This errata sheet provides updated information on Stratix® devices. This document addresses known issues and includes methods to work around the issues.

Table 1 shows these issues and which Stratix devices each issue affects.

Figure 2. Gated Lock in Internal Logic Circuit

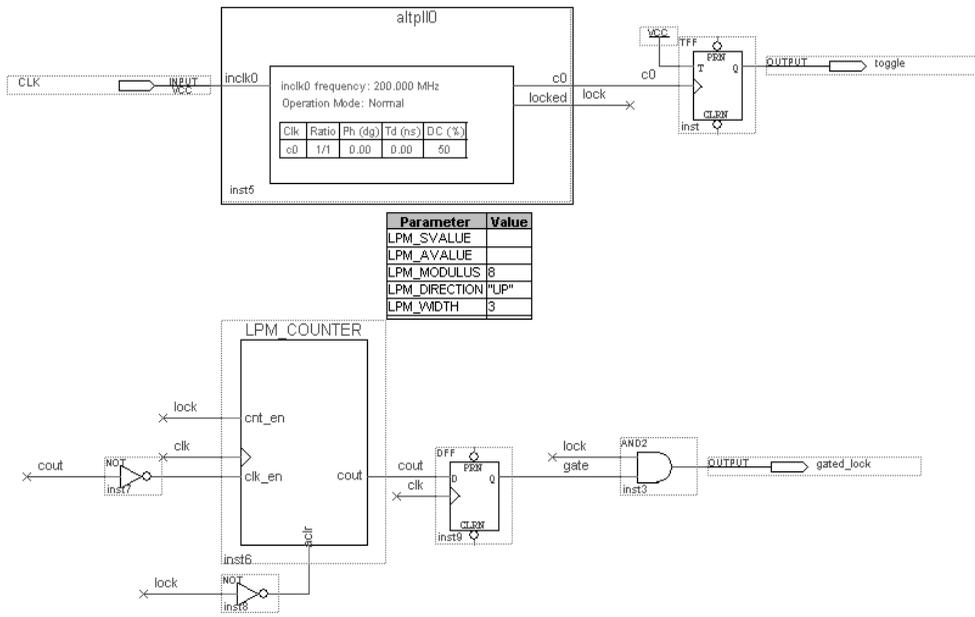
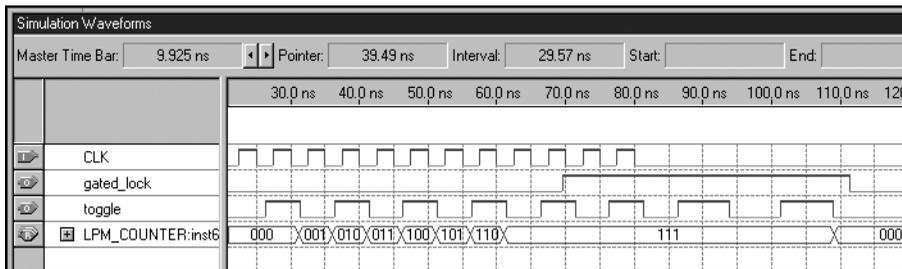
There is a run-through problem in the `GLOCK` counter that causes the counter to operate incorrectly. Support for the `gated_lock` circuitry was disabled in the Quartus II software version 2.1. Therefore, the `gated_lock` feature is unavailable in Stratix devices.

The work around for this problem is to gate the `lock` signal in internal logic. Altera recommends using a two-input `AND` gate to gate the `lock` signal with a counter. The number of bits in the counter (`LPM_WIDTH`) can be adjusted to control how many clock cycles before the `gated_lock` signal is released. The counter width in the reference design is currently 3. See [Figure 2](#).

Figure 4. Clock Switchover Circuit

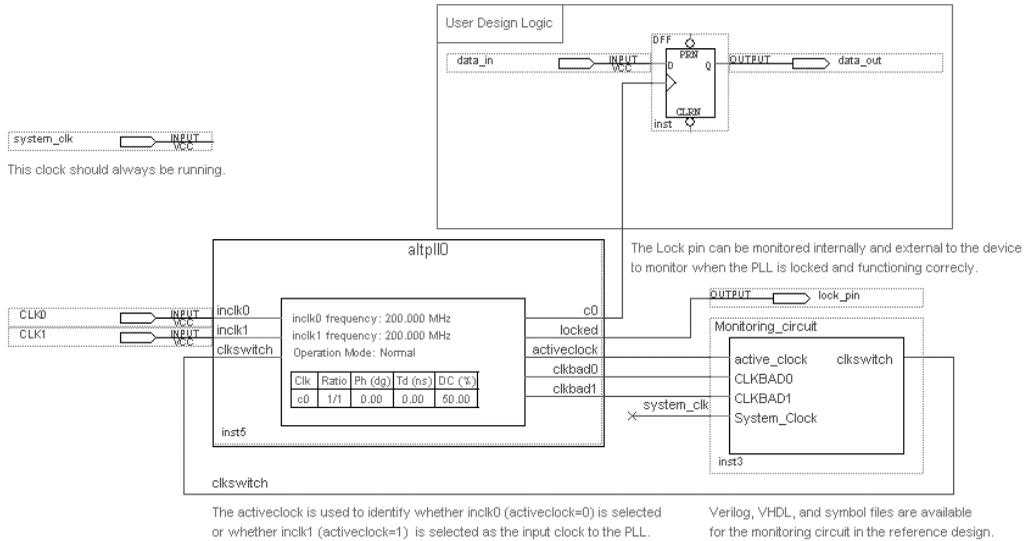
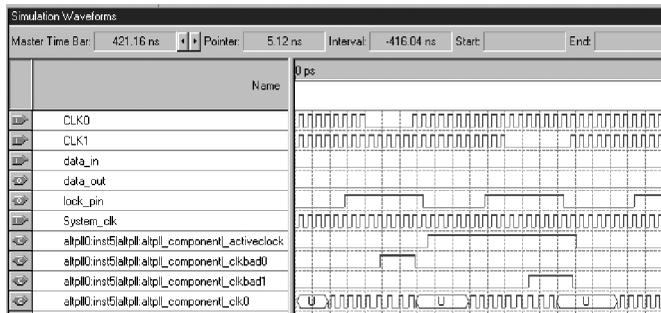
The CLKBAD0 and CLKBAD1 signals have a design flaw that cause a glitch on the signals. The glitches last for up to a half clock cycle of the input clock to the PLL. To prevent switchover from happening prematurely, a monitoring circuit is used to require the CLKBAD signal for the selected clock to be high for four consecutive system clock cycles before the PLL will switchover to the other clock.

To work around this issue, designers need to use the monitoring circuit as shown in [Figure 4](#) when designing for clock switchover. The monitoring circuit watches CLKBAD0, CLKBAD1, and the `activeclock` signals from the PLL. The monitoring circuit switches the PLL from `inclk0` to `inclk1` when CLKBAD0 is detected for four consecutive system clock cycles; the monitoring circuit switches the PLL back from `inclk1` to `inclk0` when CLKBAD1 is detected for four consecutive system clock cycles.

In the circuit shown in [Figure 4](#), CLK0 is the primary clock and CLK1 is the secondary clock. The `locked` signal can be used in the core and external to the device for monitoring the lock status of the PLL. The ALTPLL megafunction also has a `clkloss` output signal that can be monitored to determine when the clock switchover circuit initiates. `clkloss` goes high when the input clock is lost. If the primary clock fails and the secondary clock is not available, the clock switchover circuit continues to wait for a good secondary clock. The `activeclock` signal can be used in the core and external to the device for monitoring whether `inclk0` or `inclk1` is selected as the input clock to the PLL. A system clock that is guaranteed to be running at all times after the Stratix device is configured should be used to clock the monitoring circuit. Verilog HDL, VHDL, and schematic files are available in the reference design. It also contains waveform simulation and Verilog HDL and VHDL test bench files.
